SERVICE BULLETIN

N° 139-669

DATE: May 31, 2022

ATA 23 - SATCOM FLIGHTCELL DZMX ELECTRICAL VARIANT INSTALLATION

Figure 4

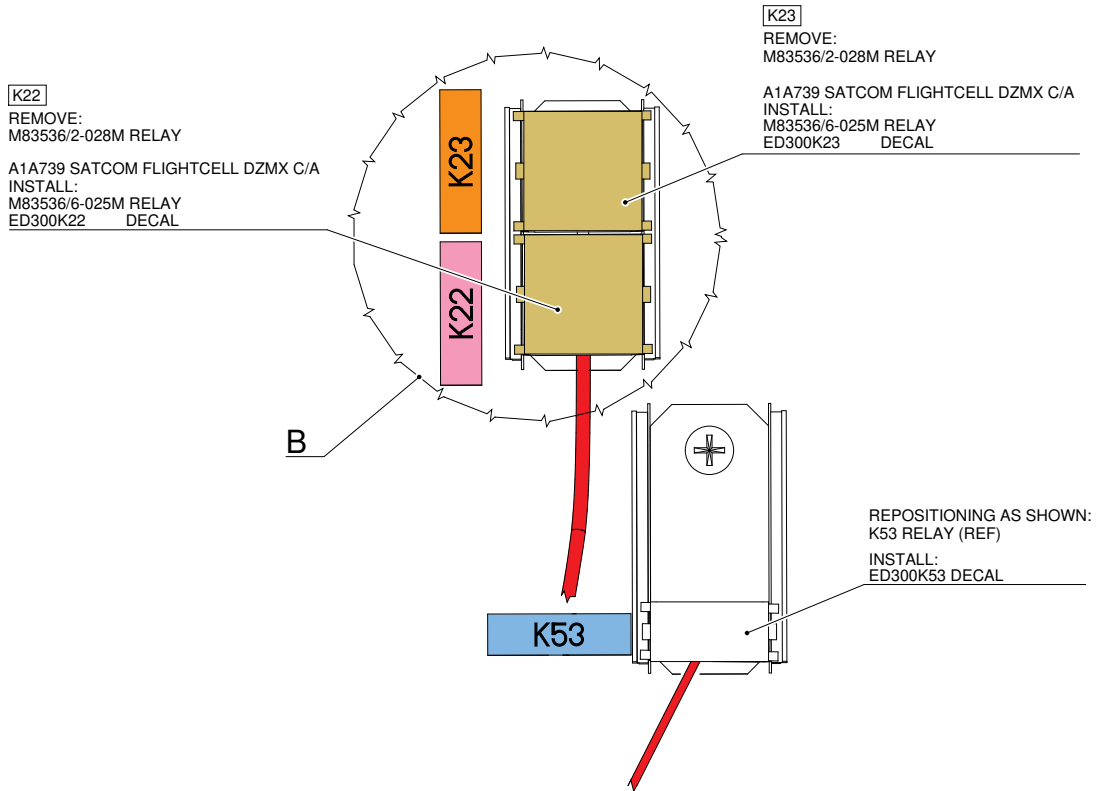
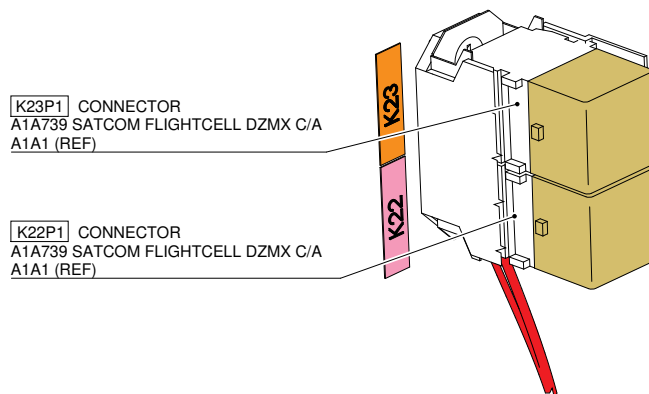
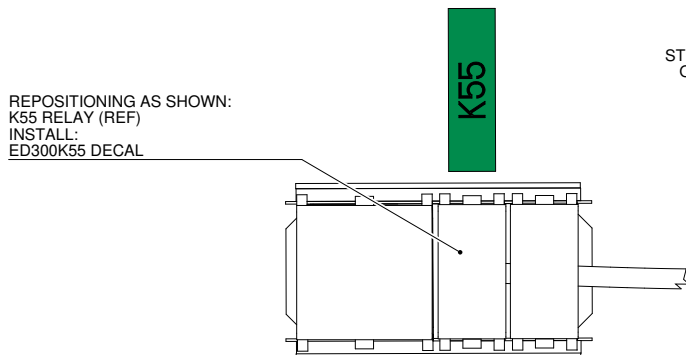
- 3.1 With reference to Figure 4 View A-A, remove n°2 relays P/N M83536/2-028M (K22 and K23).
 - 3.2 With reference to Figure 7 wiring diagram (WAS), remove the electrical connection from pin A2 of K22P1 relay socket and from pin B2 of K53P1 relay socket.

- 3.3 With reference to Figure 4 View A-A, disconnect all existing electrical connections from the K22P1 and K23P1 relay sockets. Remove the relay sockets from the relative mounting track.

- 3.4 With reference to Figure 4 View A-A, reposition the K53 relay as shown in the figure.
- 3.5 In accordance with AMP DM 39-A-11-00-01-00A-720A-A and with reference to Figure 4 View A-A, install decal P/N ED300K53 in an adjacent area to the previously installed K53 relay.

- 3.6 With reference to Figure 4 View C-C, reposition the K55 relay as shown in the figure.
- 3.7 In accordance with AMP DM 39-A-11-00-01-00A-720A-A and with reference to Figure 4 View C-C, install decal P/N ED300K55 in an adjacent area to the previously installed K55 relay.
- 3.8 With reference to Figures 1 thru 4 and Figure 7 wiring diagram (BECOMES), assemble the SATCOM Flightcell DZMX C/A (A1A739) P/N 3G9A01A73902 as described in the following procedure:
 - 3.8.1 With reference to Figure 3, 4 and Figure 7 wiring diagram, cut a wire P/N A556A-T22 of adequate length and lay down between K23P1 relay socket P/N M12883/52-002 and K22P1 relay socket P/N M12883/52-002.

- 3.11 With reference to Figure 4 View A-A, install n°2 relays P/N M83536/6-025M on the relay sockets K22P1 and K23P1.
- 3.12 In accordance with AMP DM 39-A-11-00-01-00A-720A-A and with reference to Figure 4 View A-A, install n°2 decals P/N ED300K22 and P/N ED300K23 in an adjacent area to the previously installed relays K22 and K23.

Figure 5

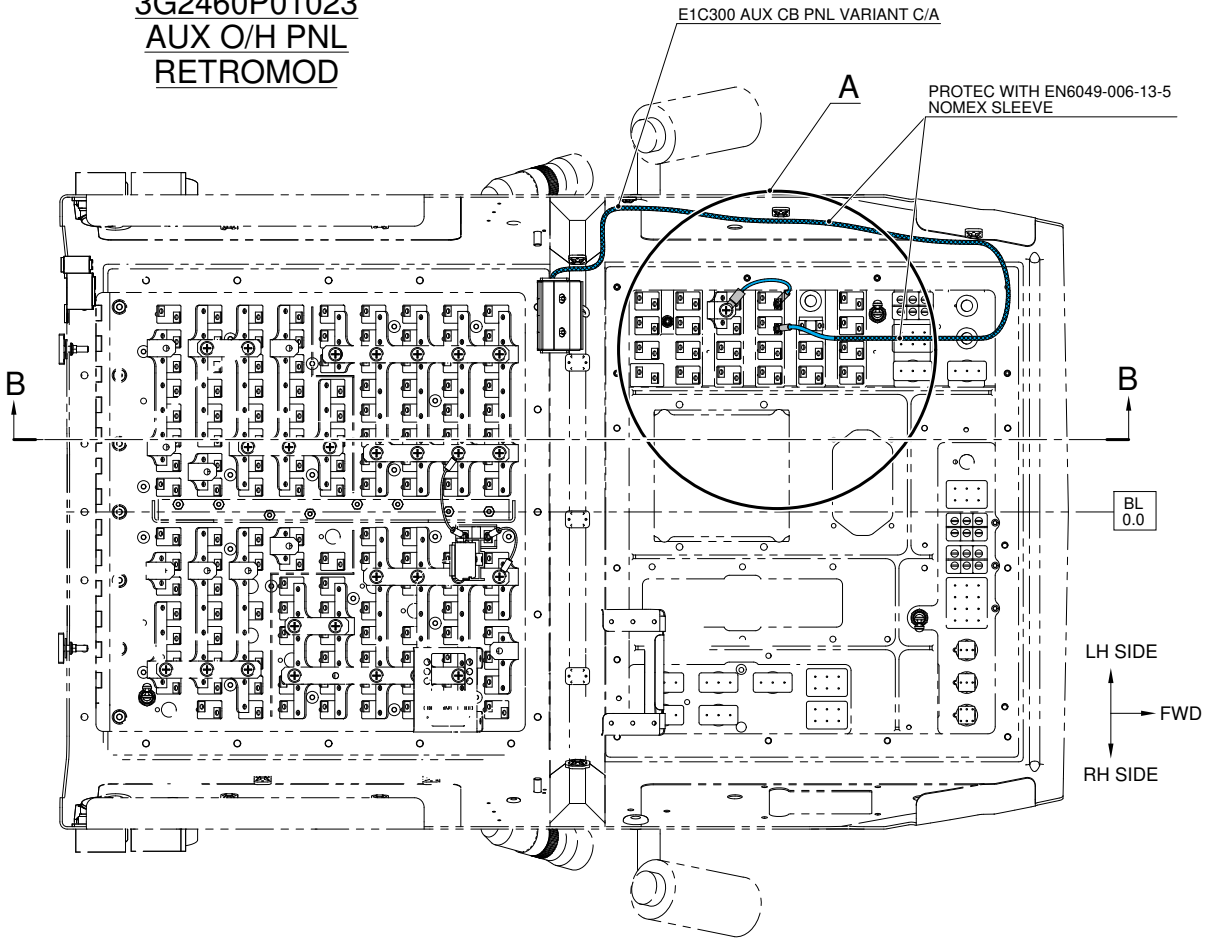
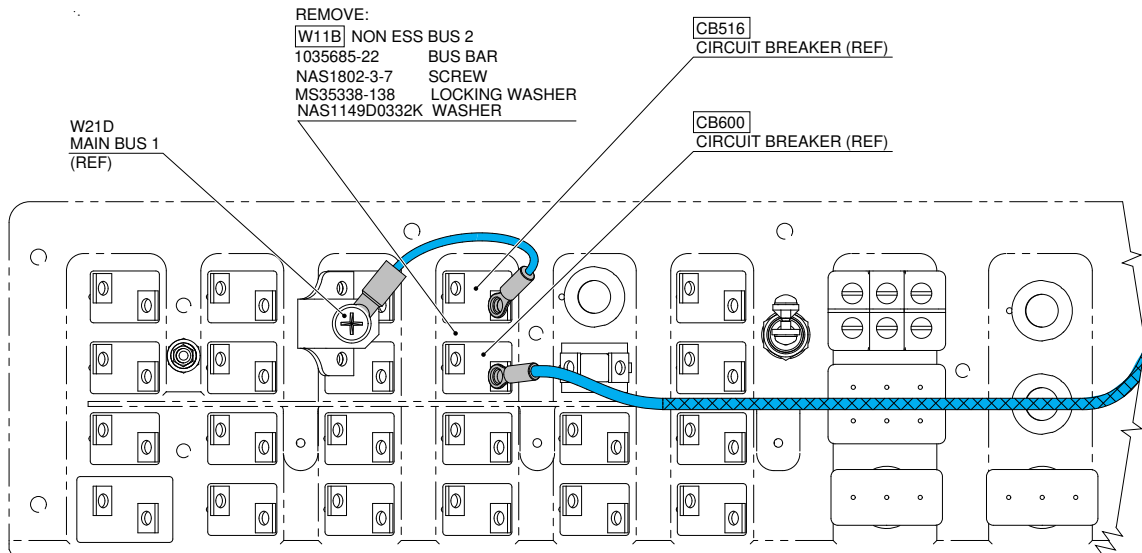
- 4.2 With reference to Figure 9 wiring diagram (WAS), disconnect, remove or stow the electrical connections as required.
 - 4.3 With reference to Figure 5 Detail A, remove bus bar P/N 1035685-22, screw P/N NAS1802-3-7, locking washer P/N MS35338-138 and washer P/N NAS1149D0332K from circuit breakers CB600 and CB516.

- 4.4 With reference to Figure 5 and Figure 9 wiring diagram (BECOMES), cut a wire P/N A556A-T16 of adequate length and lay down between circuit breaker CB516 and 28VDC main bus 1 W21D.

- 4.7 With reference to Figures 5, 6 and Figure 9 wiring diagram (BECOMES), cut a wire P/N A556A-T12 of adequate length and lay down between circuit breaker CB600 and terminal board TB511-2.

Figure 6

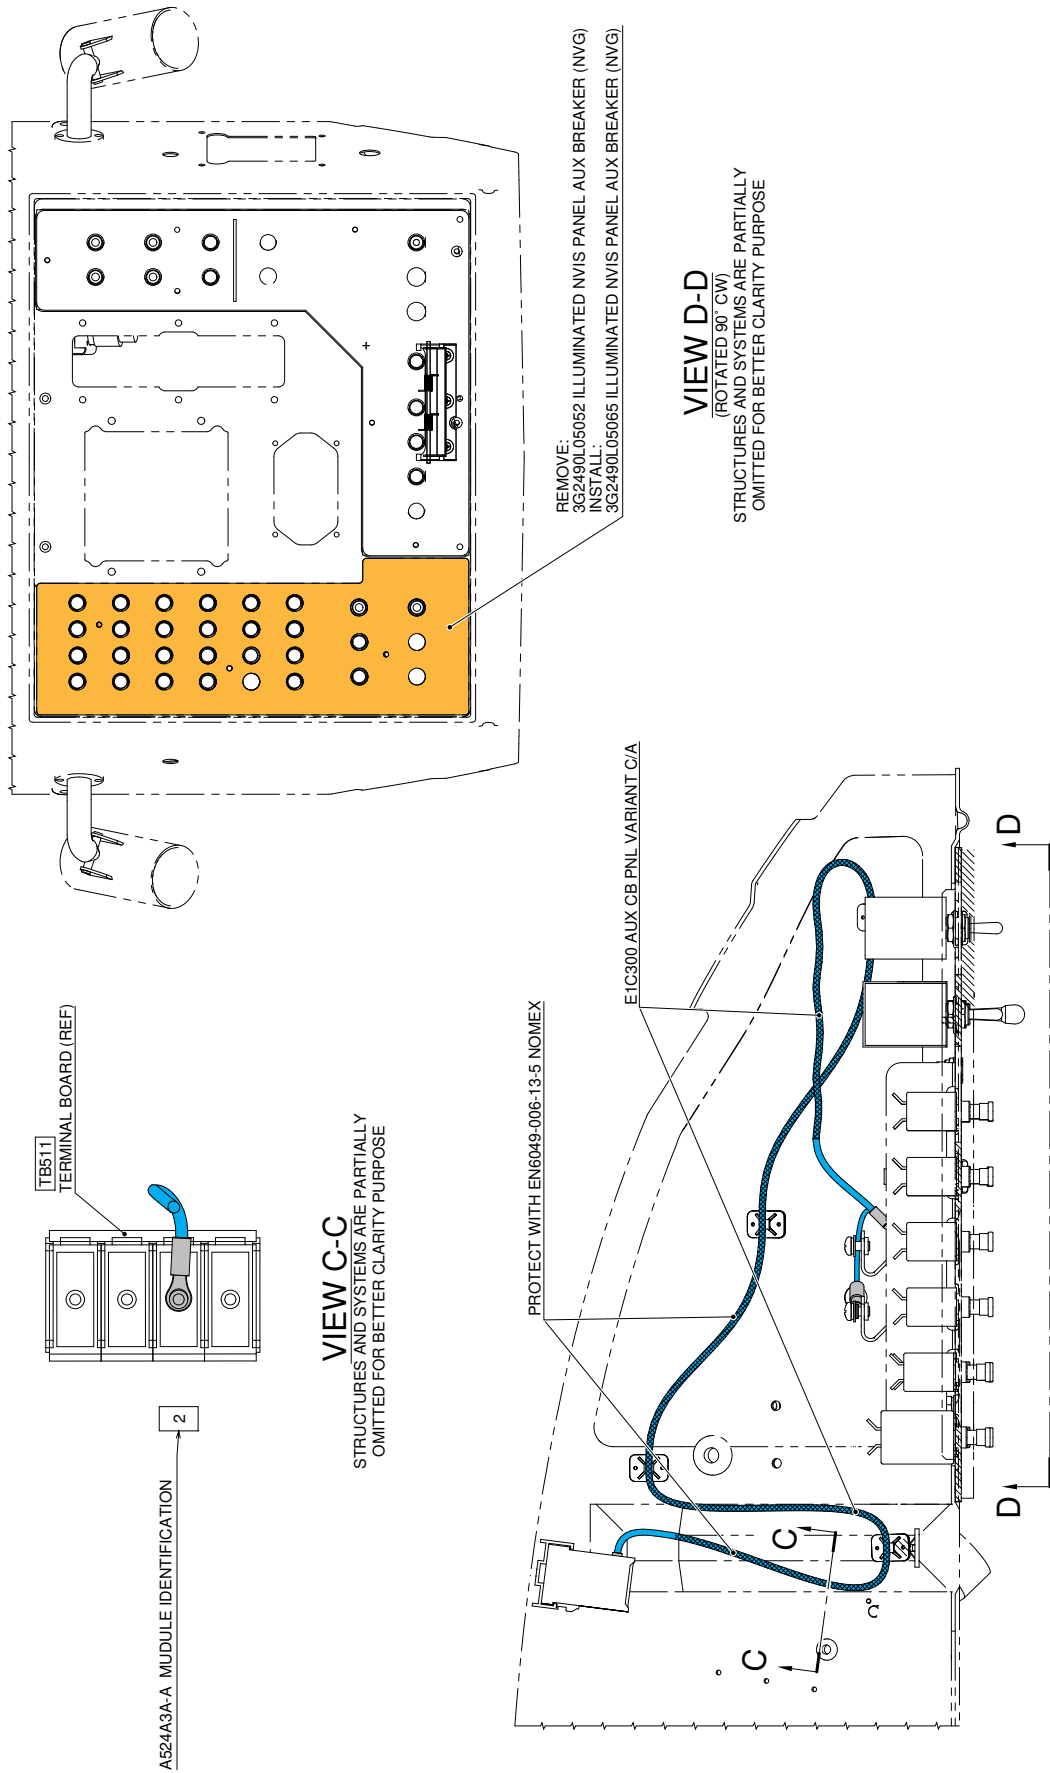
- 4.1 In accordance with AMP DM 39-A-24-91-04-00A-920A-K and with reference to Figure 6 View D-D, remove from the Overhead C/B panel the existing illuminated NVIS panel AUX breaker P/N 3G2490L05052 and install the new illuminated NVIS panel AUX breaker P/N 3G2490L05065.

Figure 7

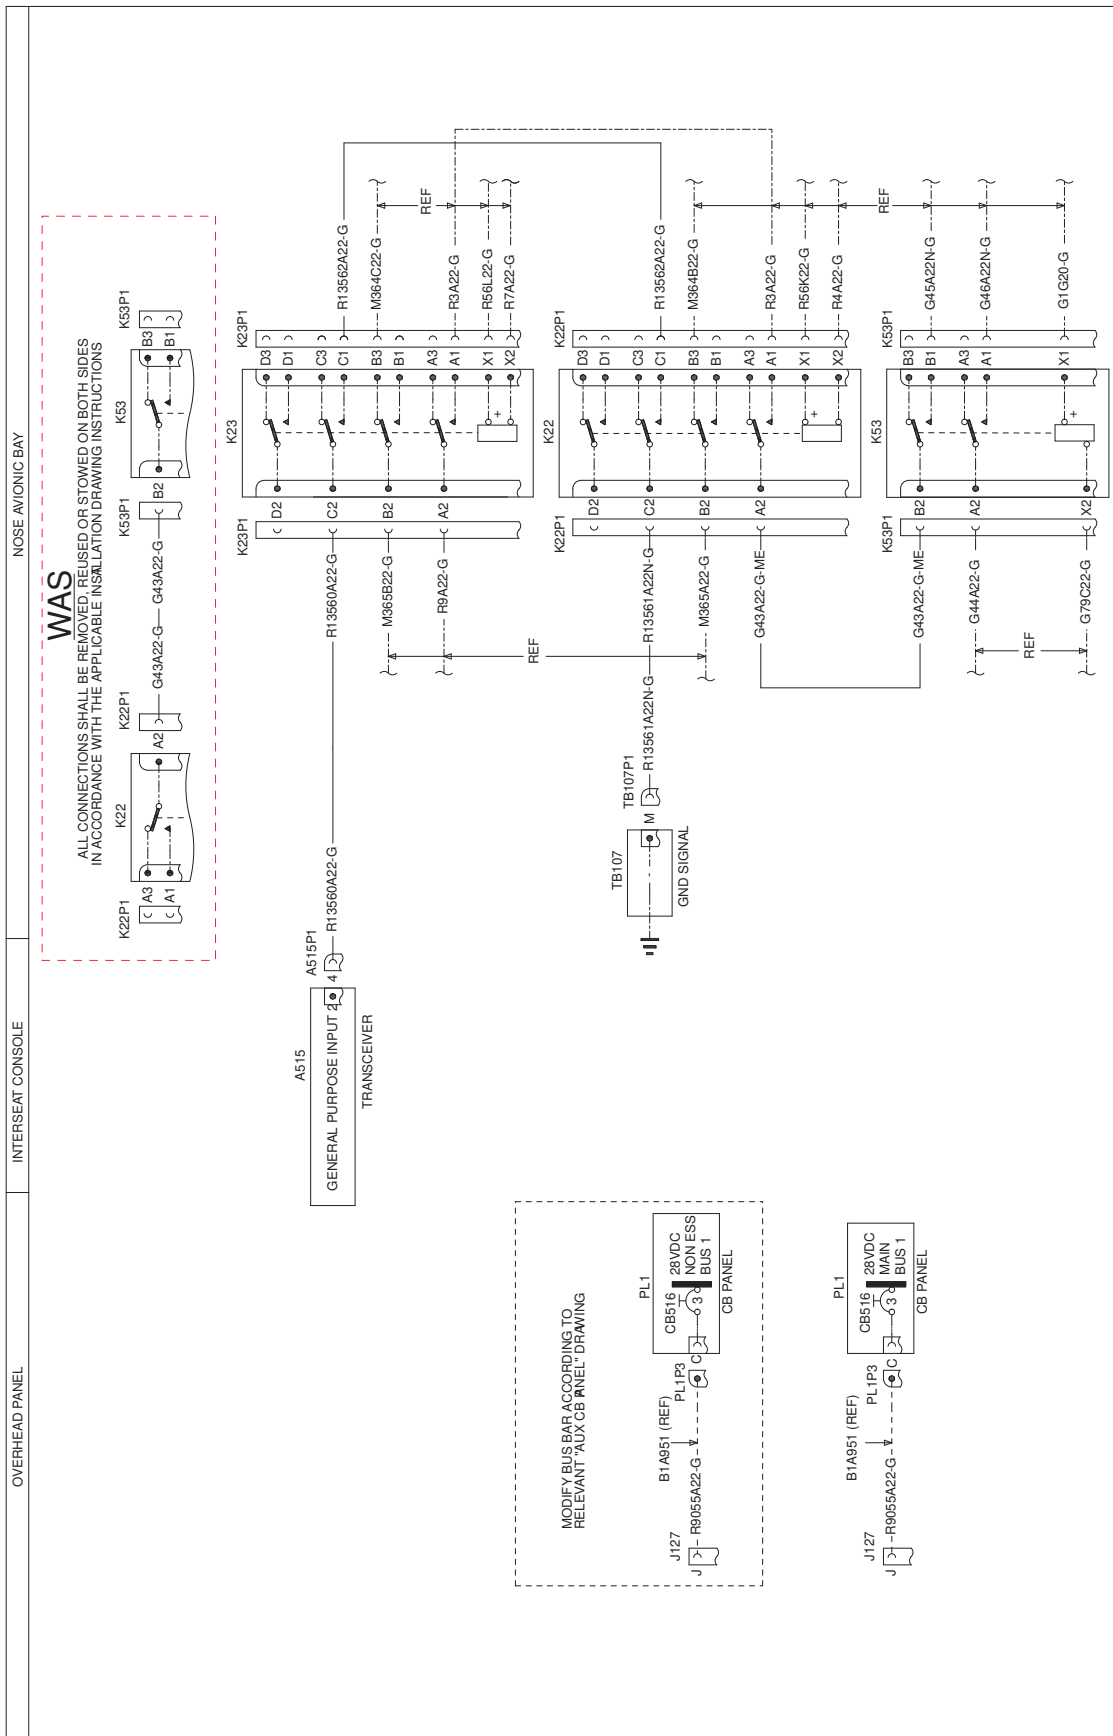
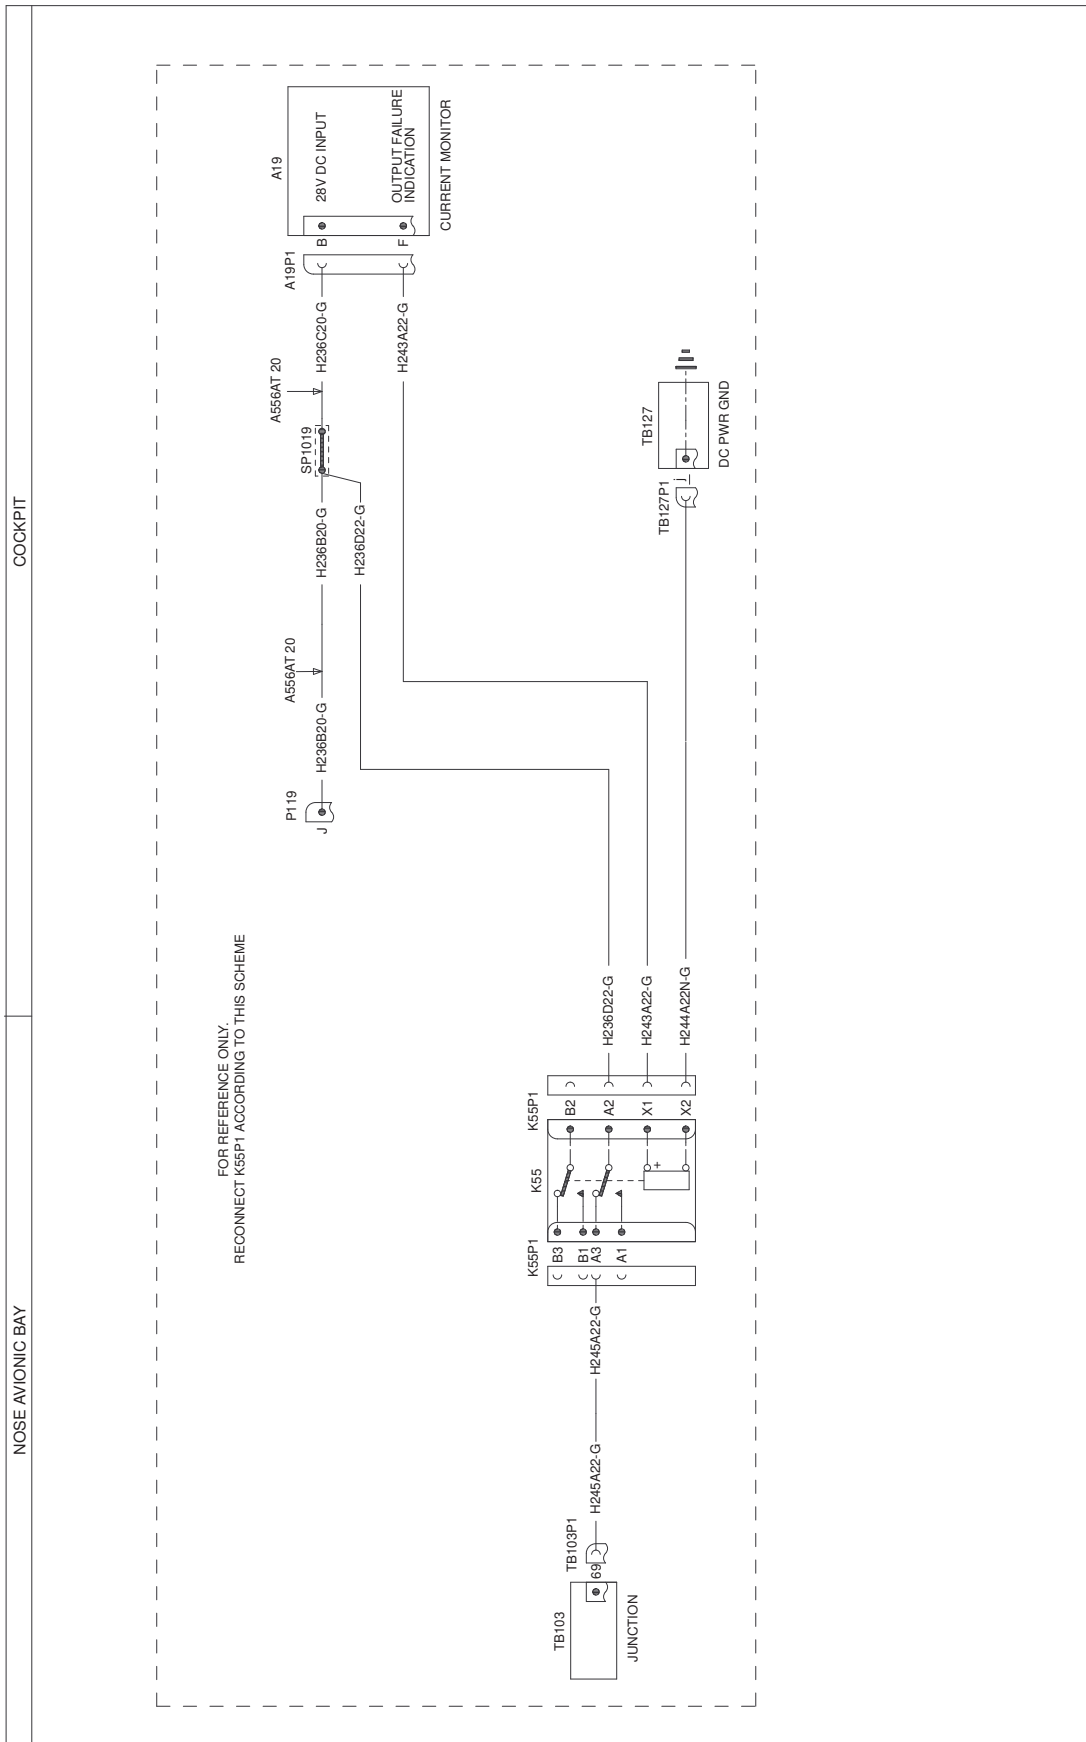
- 3.8.2 In accordance with AMP DM 39-A-20-10-08-00A-622A-A and with reference to Figure 7 wiring diagram, crimp on wire an electrical contact P/N M39029/101-553 (K23P1 side) and an electrical contact P/N M39029/101-553 (K22P1 side) by means of proper crimping tool.

- 3.8.3 In accordance with AMP DM 39-A-20-10-18-00A-691A-A and with reference to Figure 7 wiring diagram, mark wire as R13562A22-G by means of marker sleeve P/N A578A.

- 3.8.5 In accordance with AMP DM 39-A-20-10-08-00A-622A-A and with reference to Figure 7 wiring diagram, crimp on wire an electrical contact P/N M39029/63-368 (A515P1 side) and an electrical contact P/N M39029/101-553 (K23P1 side) by means of proper crimping tool.

- 3.8.6 In accordance with AMP DM 39-A-20-10-18-00A-691A-A and with reference to Figure 7 wiring diagram, mark wire as R13560A22-G by means of marker sleeve P/N A578A.

- 3.9 With reference to Figures 2 thru 4 and Figure 7 wiring diagram (BECOMES), perform the electrical connections of SATCOM Flightcell DZMX C/A A1A739 between TB107P1 GND signal connector, A515P1 transceiver connector and the relay sockets K22P1, K23P1 and K53P1.

- 3.10 With reference to Figure 7 wiring diagram (BECOMES), restore the electrical connections, previously removed at step 3.3, to the relay sockets K22P1 and K23P1.
